City of Fredericksburg

Planning and Zoning Meeting Agenda
Wednesday, January 8, 2025 ~ 5:30 PM
New City Hall at East Campus
2818 E. U.S. Hwy. 290
Fredericksburg, Texas 78624

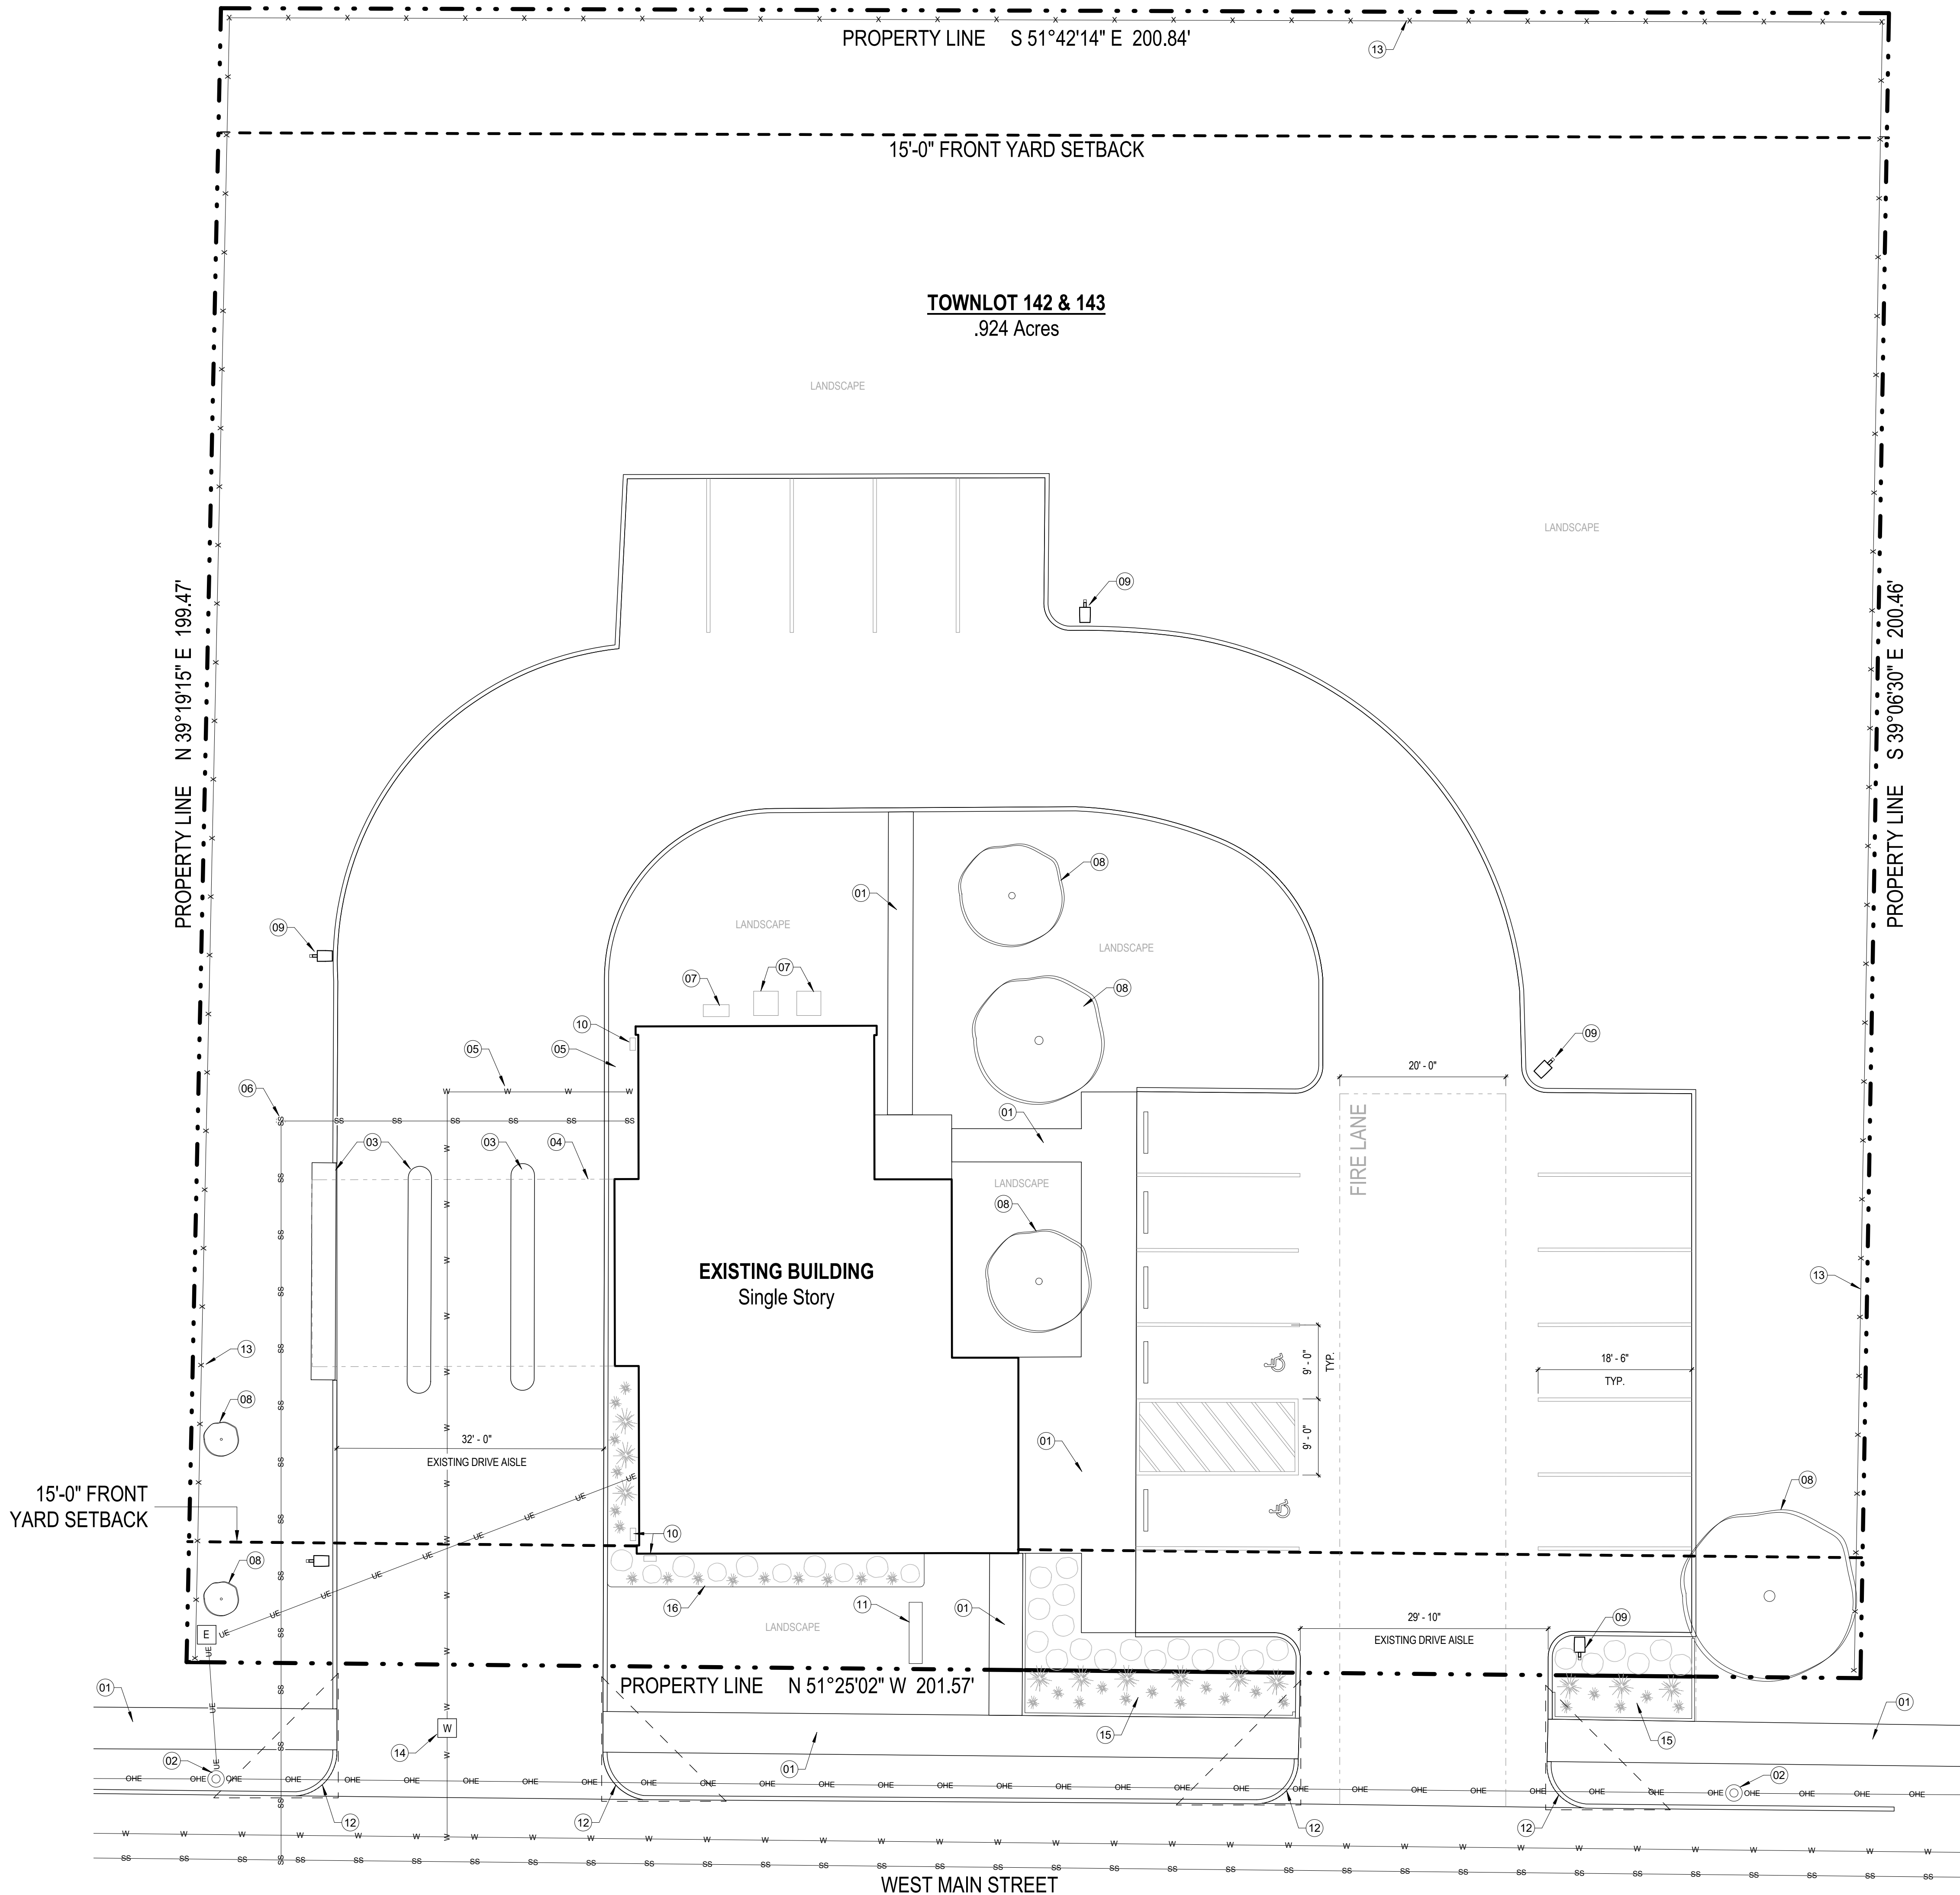
- Provide a notarized document indicating the number of current and/or proposed locations as well as the closest location to Fredericksburg, Texas. [Sec. 5.461](#)
- Renderings of signage to include placement and colors as well as examples of signage at other locations. [Sec. 5.461](#)
- Provide sign proposals, must be compliant with [Chapter 29 – Sign Ordinance, 29-7,3](#)
- Identify loading/unloading zones [Sec. 7.131](#)
- Identify placement of dumpster and/or trash receptacles [Sec. 7.131](#)
- All refuse collection must be screened per [Sec. 7.940](#)

- Please provide a solid waste container with appropriate screening per Section 7.980 of the City's Code of Ordinances.
- Please keep all proposed landscaping within the property line.

REVISED SITE PLAN

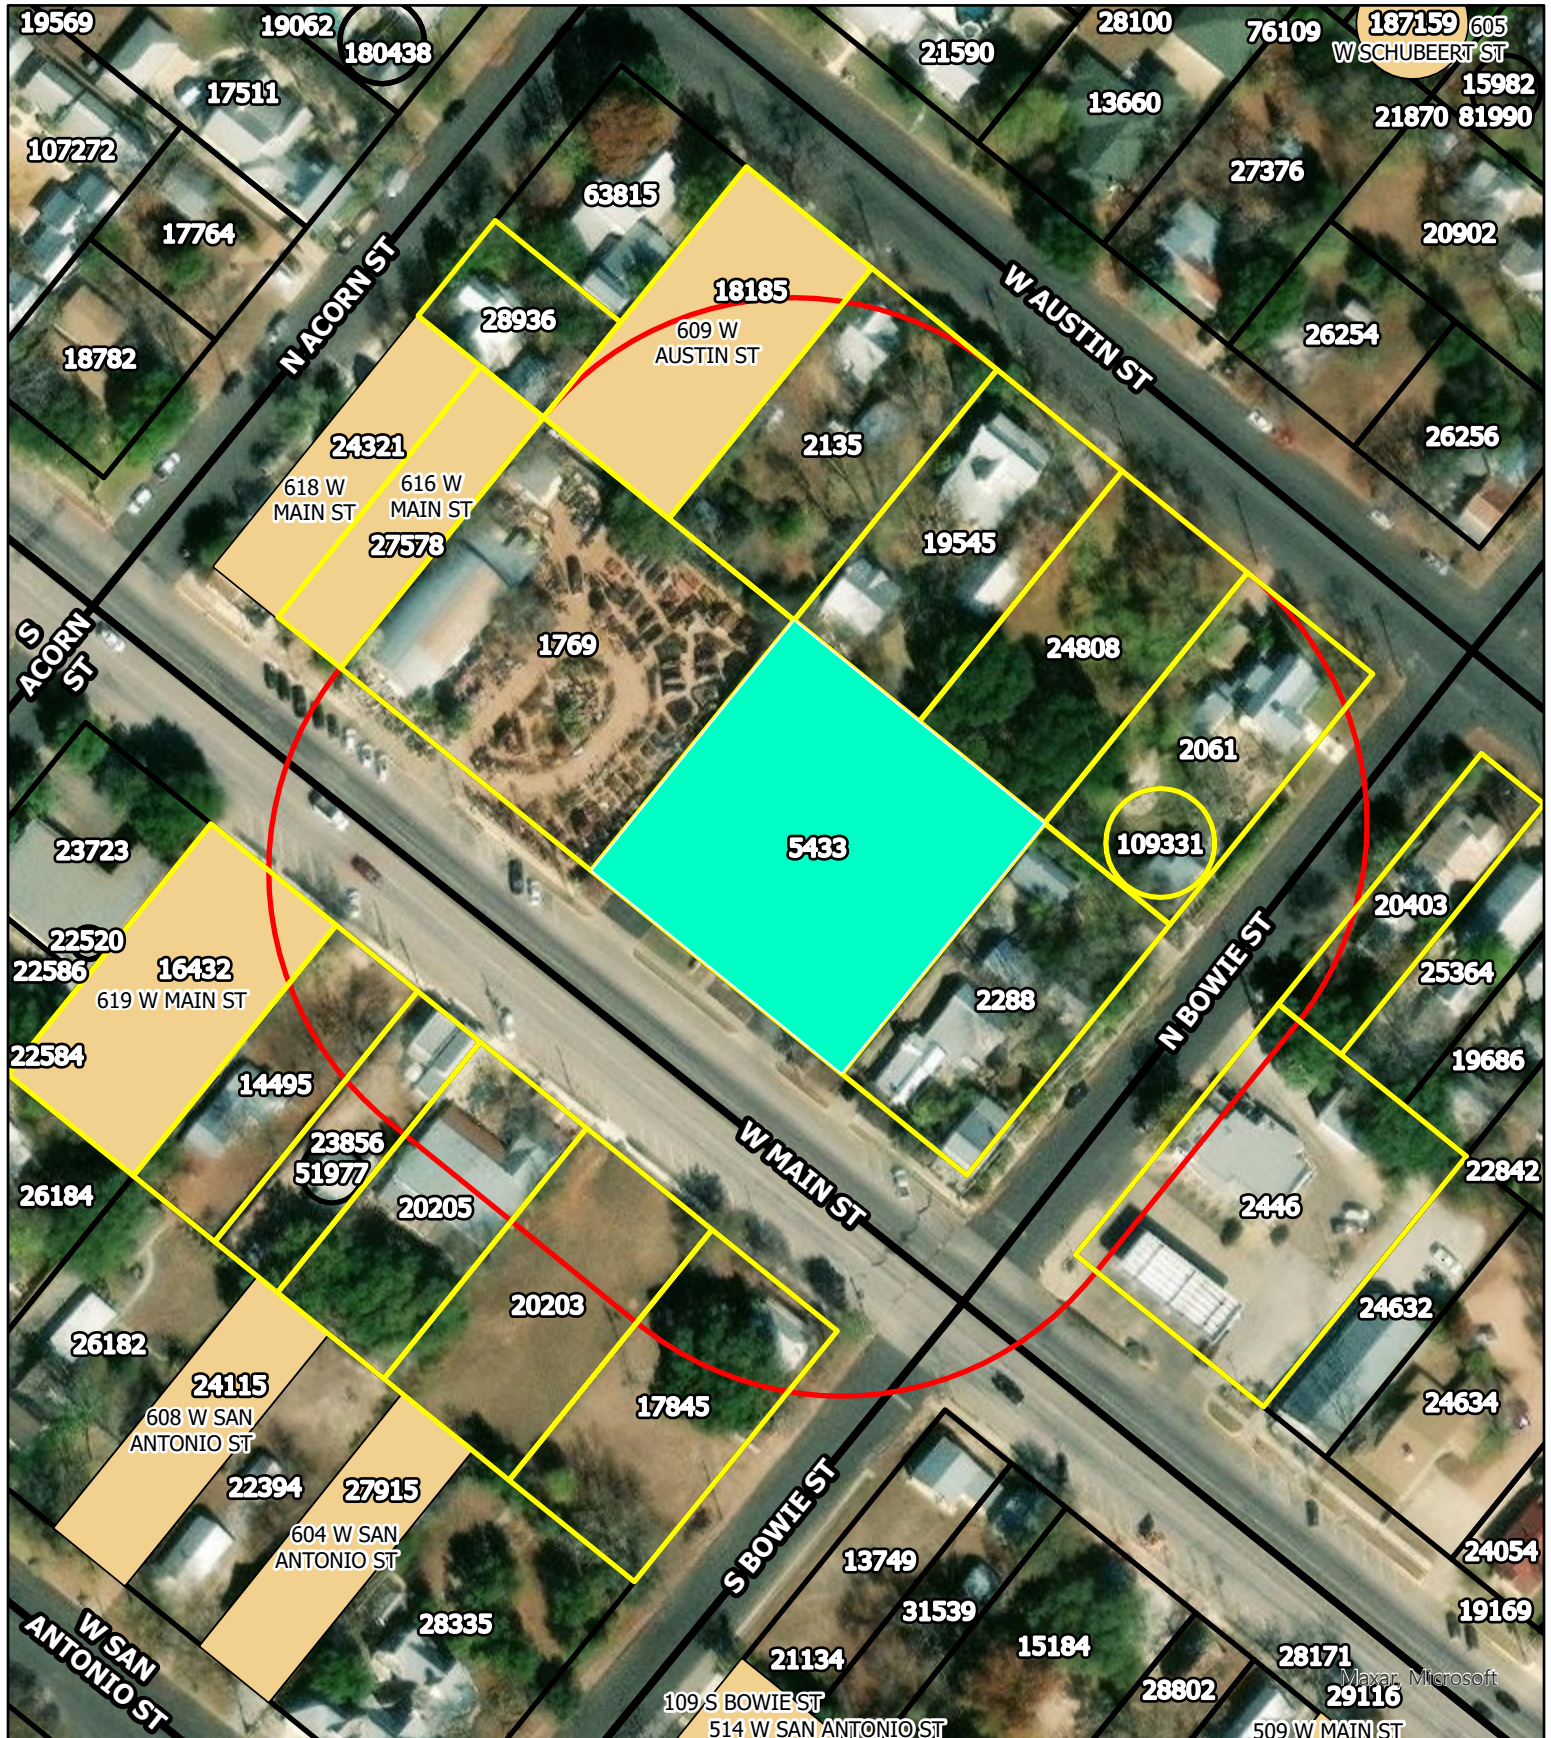
7. Please provide a solid waste container with appropriate screening per Section 7.980 of the City's Code of Ordinances.

The Site Plan has been revised to include a dedicated loading zone. Refer to attachment.

Trash receptacles and an enclosure has been located Plan-North of the existing building. The Site Plan has been revised to include trash receptacles. Refer to attachment.

The Site Plan has been revised to include a trash receptacle enclosure. Refer to attachment.

Trash receptacles and an enclosure has been located Plan-North of the existing building. The Site Plan has been revised to include trash receptacles. Refer to attachment.

N. CHERRY ST SUBDIVISION

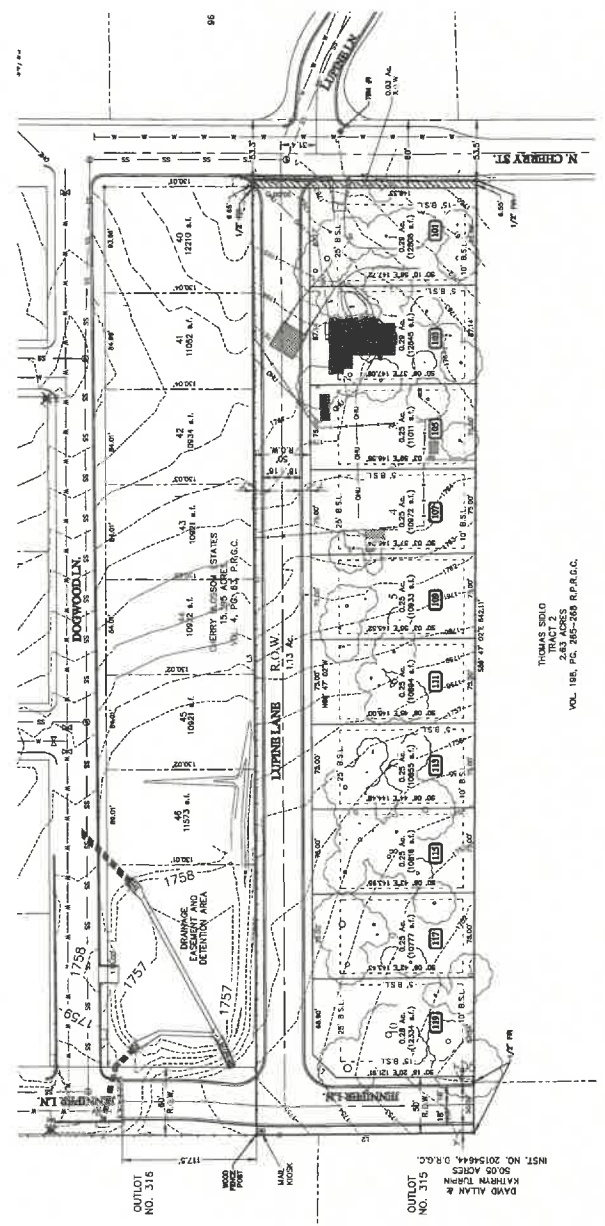
1. Add project number P-2425 to the Plat.

2. Provide a clean plat for review, the plat submitted has the "comments" feature on making the plat difficult to read.

6. *The Comprehensive Plan calls for neighborhood placemaking elements that add Community character and support pride of ownerships. Examples are sidewalks, pocket parks and street trees. **Action N.1.A.6. – Comprehensive Plan / Sec. 4.4.G.7 – Subdivision Ordinance.***

7. *The Comprehensive Plan calls for a connected network of sidewalks, paths and/or bike routes within neighborhoods and connecting to nearby collector and arterial streets. **Action M.1.B.1. – Comprehensive Plan / Sec. 4.4.G.7. – Subdivision Ordinance.***

9. *Drainage calculations will also be reviewed during civil construction plan review and more comments may be generated at that time. The water surface elevation must comply with City design standards for encroachment into the local street.*

The project number P-2425 has been added to the plat.

We have locked the plans for the reviewer to avoid this issue.

Based on the meeting with the Planning Department and Engineering staff on Thursday, December 12th, the northern roadway alignment reflects the decision reached during that meeting as the best alignment for the area.

The existing detention facility design has been revised to include the proposed subdivision storm water runoff while maintaining required City standards. The 100-year W.S.E. is maintained within the existing detention and drainage area and does not encroach on local streets.

These have been labeled as “private” on the plans.

The mailbox kiosk location has been shown and included in the plans along Jennifer Lane.
